**RE: Response to Comments on Regular Exploration Application, Tererro Exploratoion Project,  
Permit No. SF040ER, Comexico, LLC**

Comexico LLC ("Comexico") have prepared responses to comments provided by the New Mexico Mining and Minerals Division ("MMD") on April 27, 2020 on the Tererro Exploration Project, Permit No. SF040ER.

**Figure 1**  
**Laydown Area**

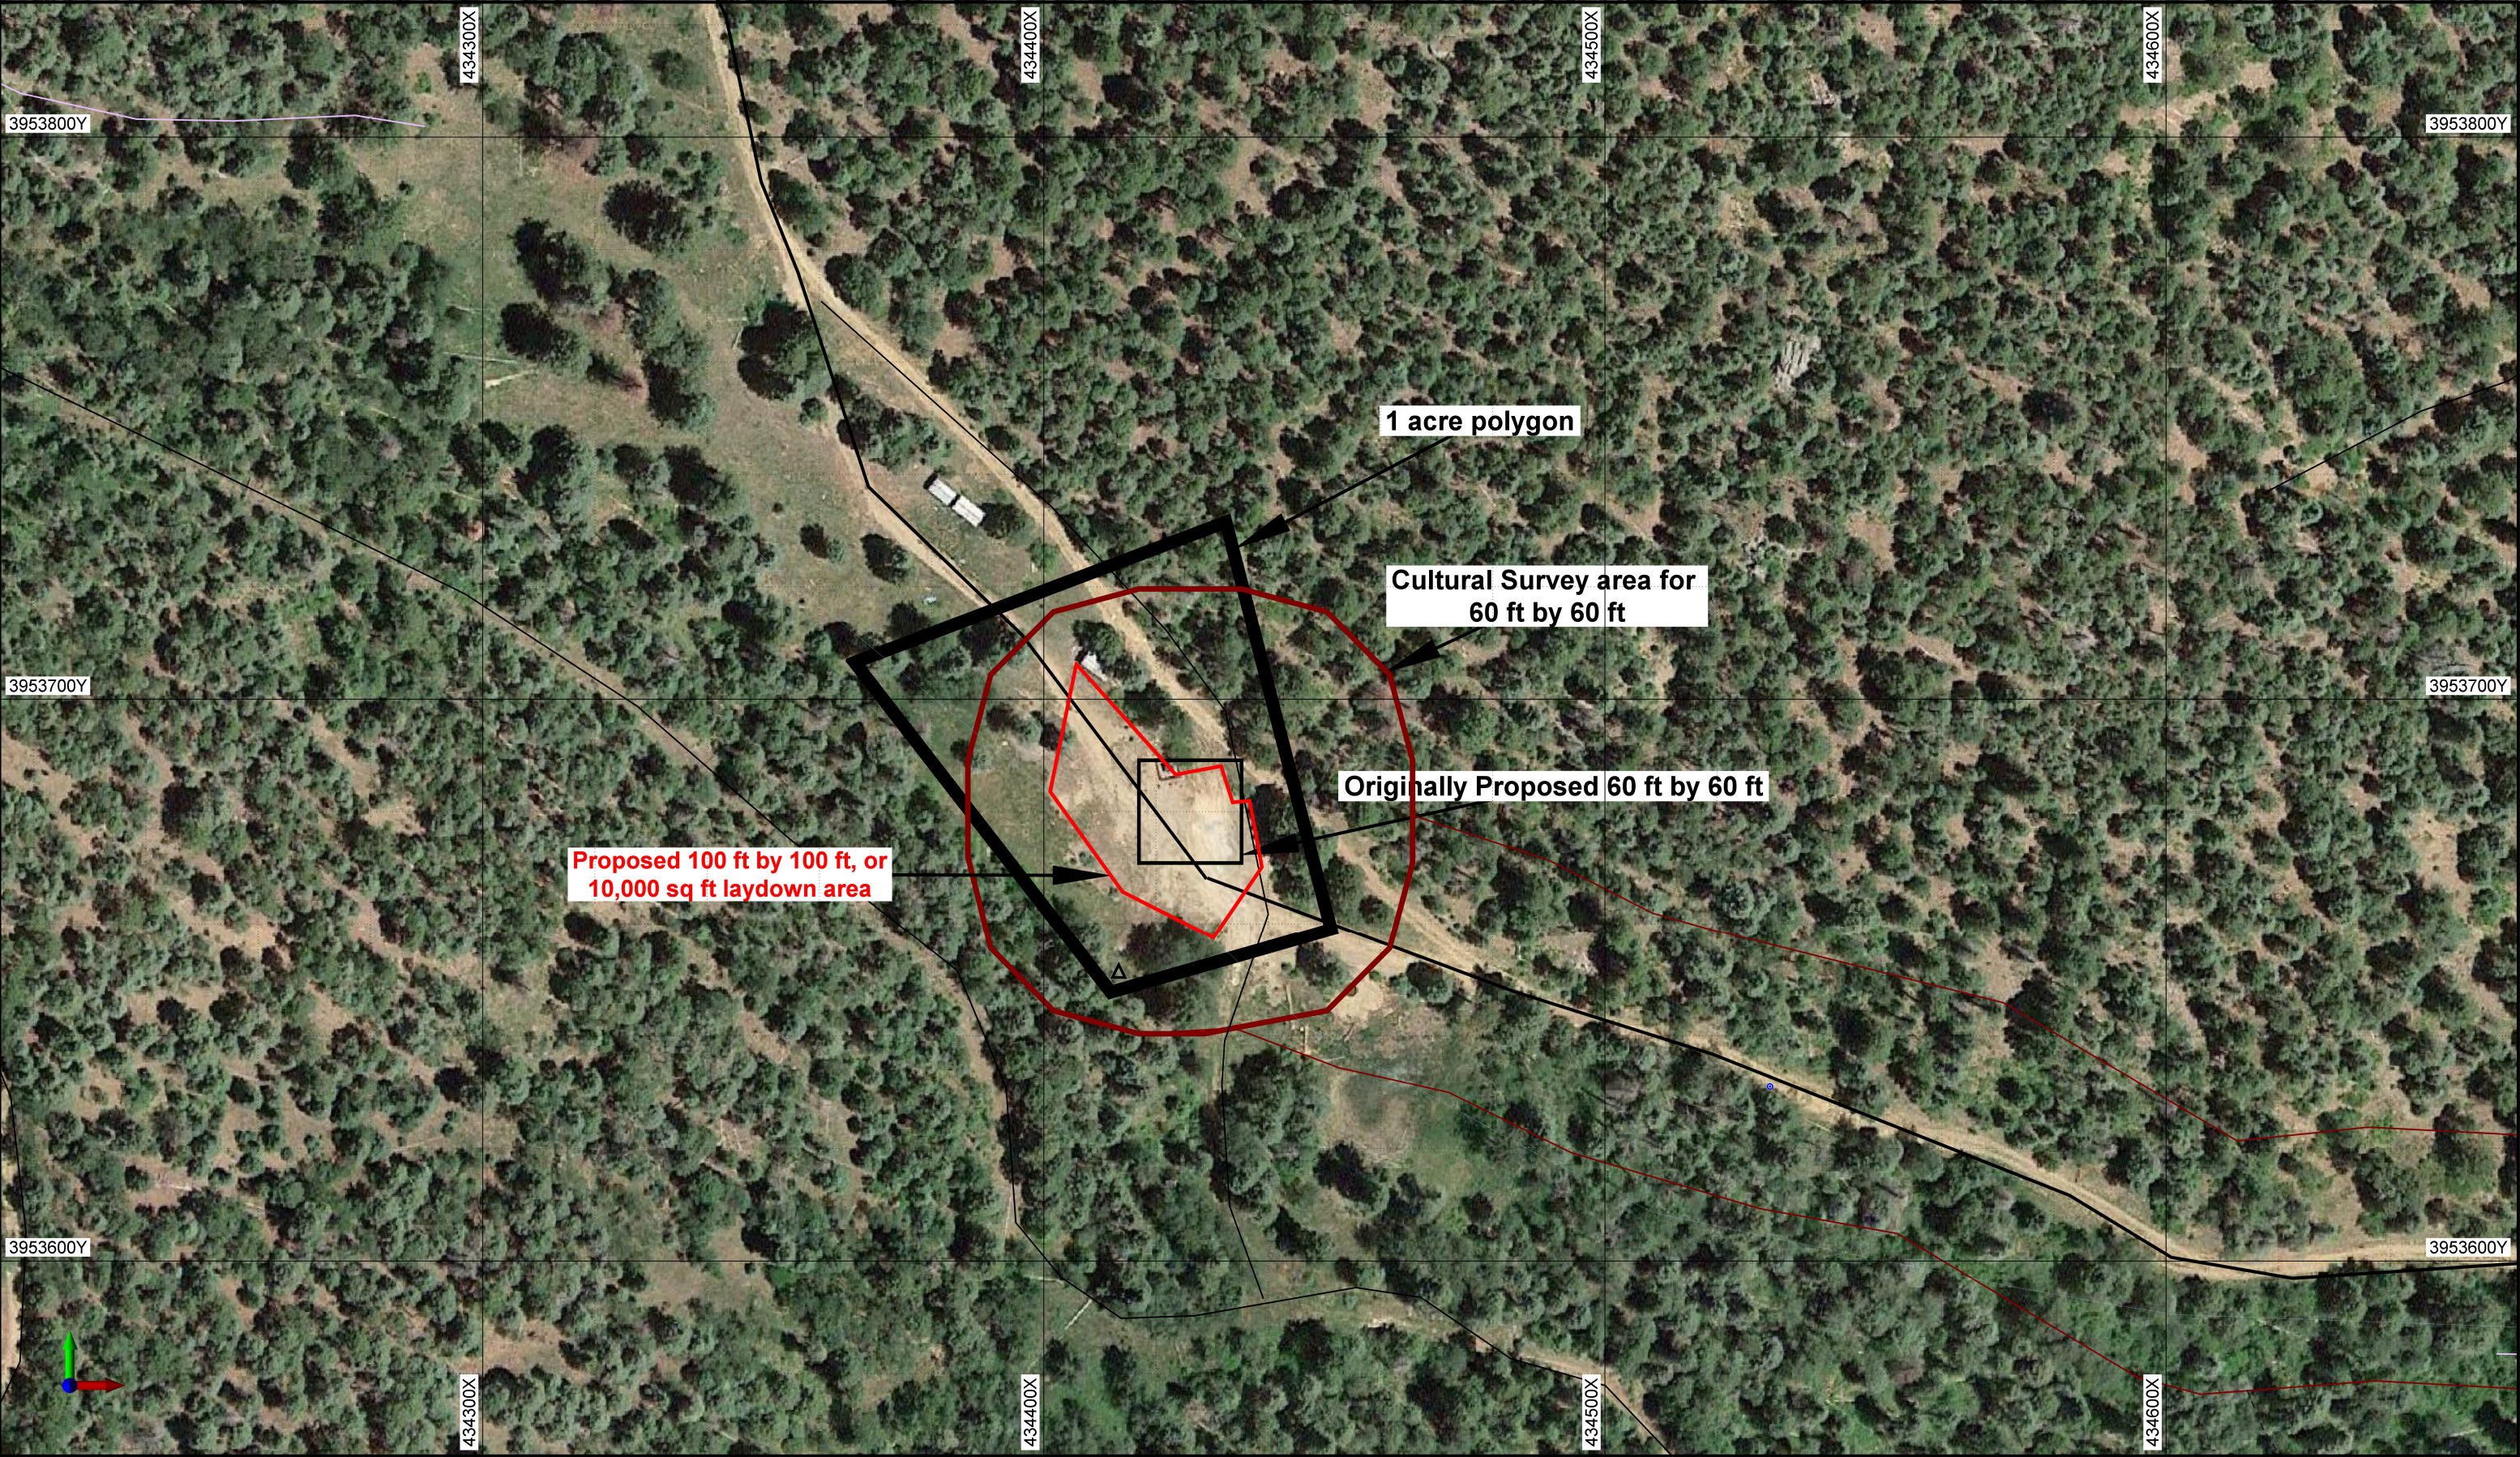
Comexico does not agree with the USFS' assessment that the proposed laydown area will require 1 acre (Figure 1, electronically attached) and instead proposes an area of 100 ft by 100 ft – this area is upon an area of existing disturbance.
